### **BOARD ACTION REPORT – APPEALABLE ITEM**

**Project Name:** 131 NW 1st Avenue  
**Project Location:** 131 NW 1st Avenue, Old School Square Historic District  
**Request:** Certificate of Appropriateness (2019-150)  
**Board:** Historic Preservation Board  
**Meeting Date:** November 6, 2019

## HISTORIC PRESERVATION BOARD STAFF REPORT

131 NW 1<sup>st</sup> Avenue

1 1st FLOOR REFLECTED CEILING / LIGHTING PLAN  
1/4"=1'-0"

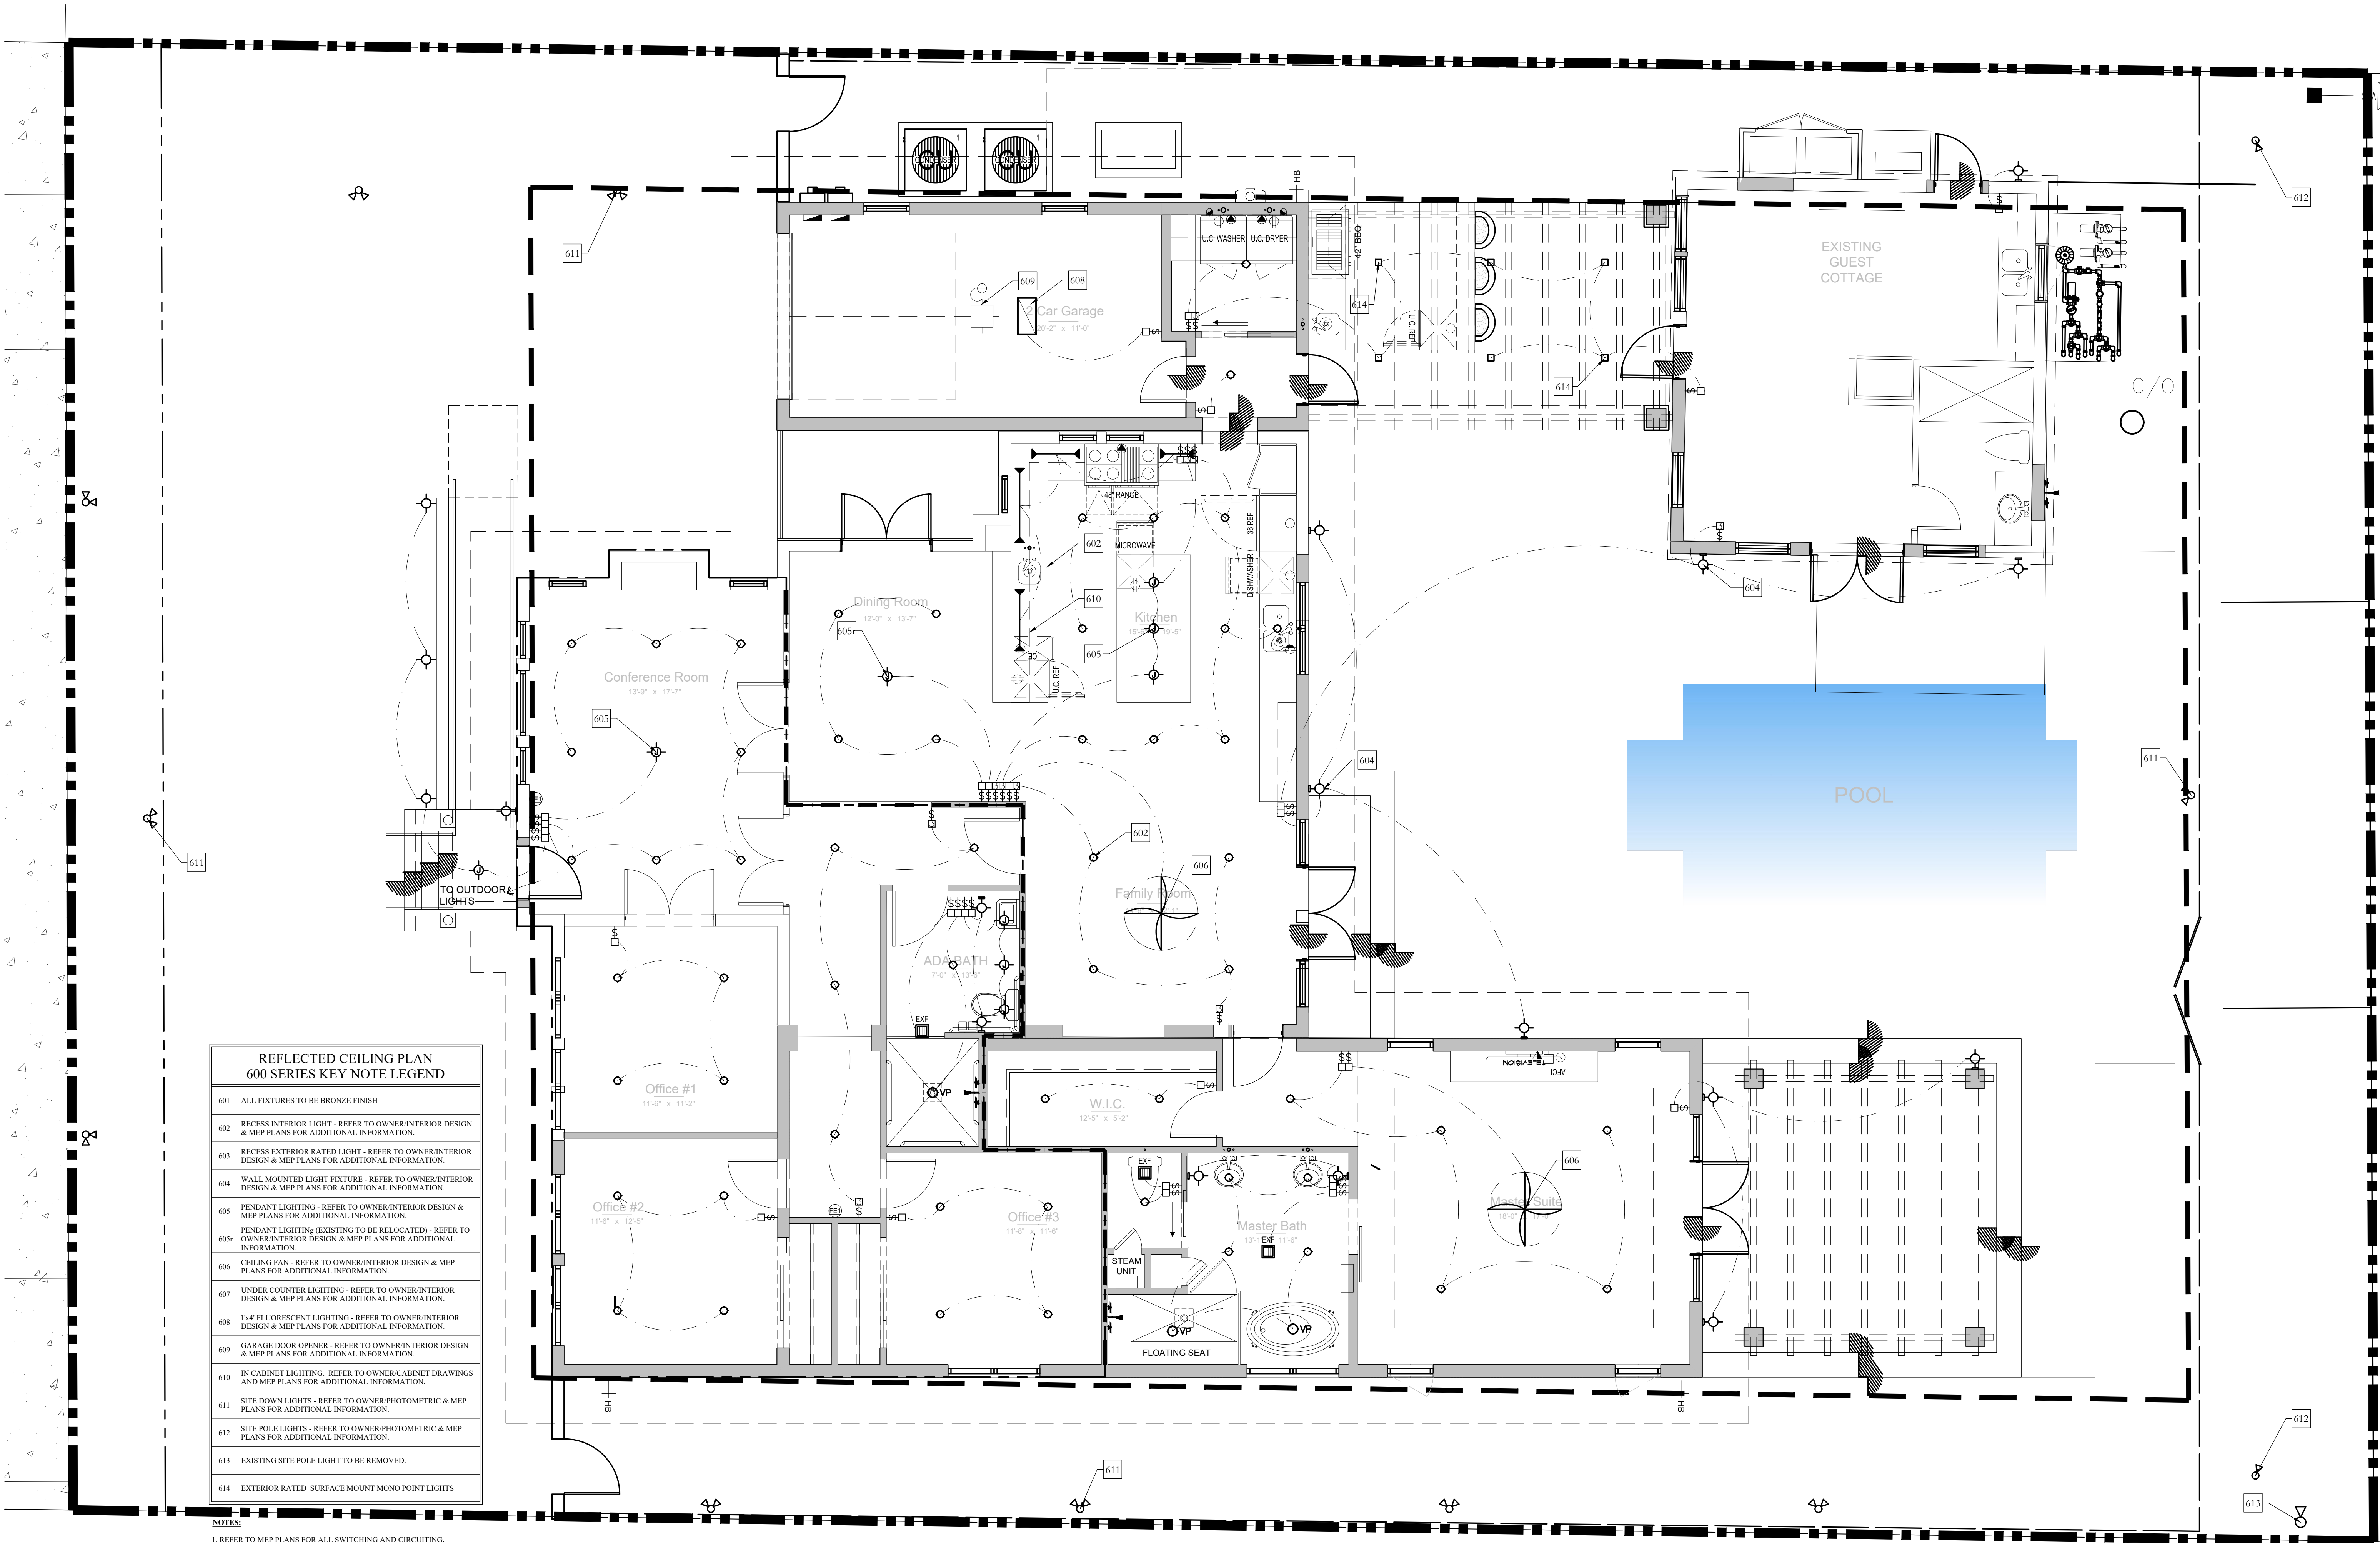
6. That site lighting calculations be provided on the Photometric Plan for the parking area on the east side of the property adjacent to the north/south alley.
